# Access Compliance Report

### (Curb Ramps)

Intersection ID: 53018	Main Street: STEEL_HOUSE_BV	Cross Street: SPENCER_ST	Location: NW
ADA ID: 165BEC9A2831	Ramp Type: BlendTrans2	Initial Pass/Fail: Pass	Overall Compliance: No
Codes/Mitigation Info/Possible Solution		Field Measurements/Component Compliance	
Severity Score: 17.5

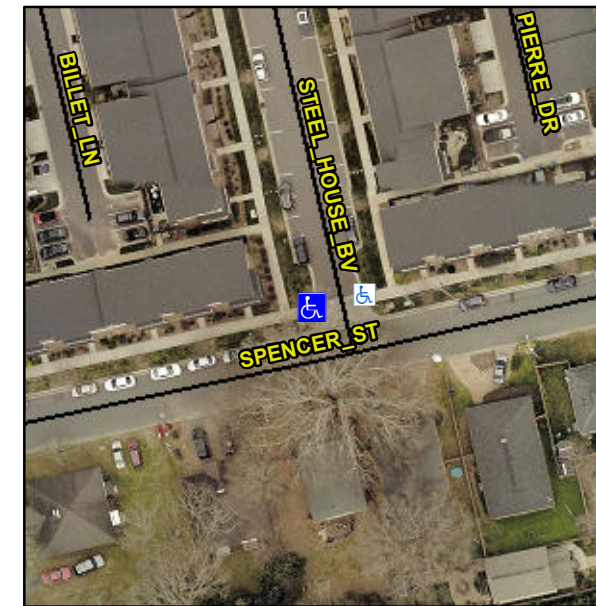
**Install Detectable Warning System.  
Grind Gutter Lip.**

**COLLECTED WITH ULIP**

**R305, R302.7.2**
